UNITED STATES PATENT AND TRADEMARK OFFICE

APPLICATION NO.	FILING DATE	FIRST NAMED INVENTOR	ATTORNEY DOCKET NO.	CONFIRMATION NO.
10/583,238	06/16/2006	Albrecht Hofmann	3477	8264
7590 Striker Striker & Stenby 103 East Neck Road Huntington, NY 11743			EXAMINER KLAUS, LISA NHUNG	
			ART UNIT 2833	PAPER NUMBER
			MAIL DATE 12/17/2009	DELIVERY MODE PAPER

Office Action Summary

DETAILED ACTION

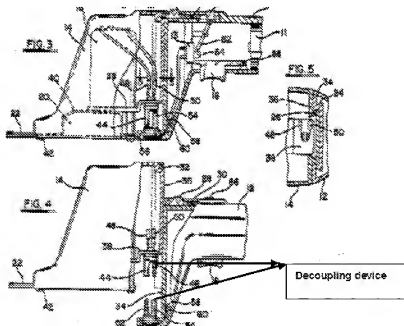
Claim 1 is rejected under 35 U.S.C. 102(b) as being anticipated by Owings et al.
(US 3,952,239), figure 1.

Owings discloses a modular cordless tool comprising:

- a power supply unit 11 that can be removed on the device side for supplying electrical power, with at least one indirectly actuatable switch for switching a drive machine on and off, wherein a decoupling device (see figure below) decouple the switch 64 and a switching means 16 that actuates the switch 64 (from the rest of the unit 14).
